**From:** Wooldridge, John  
**Sent:** Thursday, June 11, 2020 12:20 PM  
**To:** Heim, Kimber  
**Subject:** RE: 110412 FAI 037 Safety Project D5 Requests Cost Proposal ASAP

**Subject:** RE: FAI-37-6.34 Preliminary Right of Way Plans (PID No. 110412)

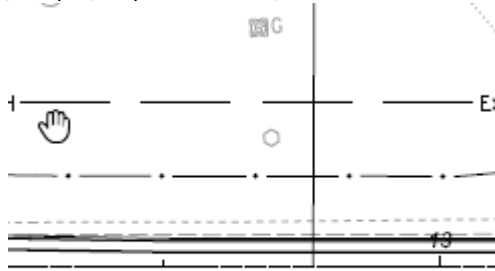
- Missing sheet 20 of 37 as Luke stated.
- Page 21/36 (22/37) Parcel 11-SH shows "Utility Pole Save" for private light poles. I would have them removed as ODOT will need to pay for them anyways (in take area) and would need to do a permit (not recommended) for the poles that are very close to the fence needing removed. Same Parcel has three of those poles (not 2) and also has a small sign near the fence that was not picked up on these plans:
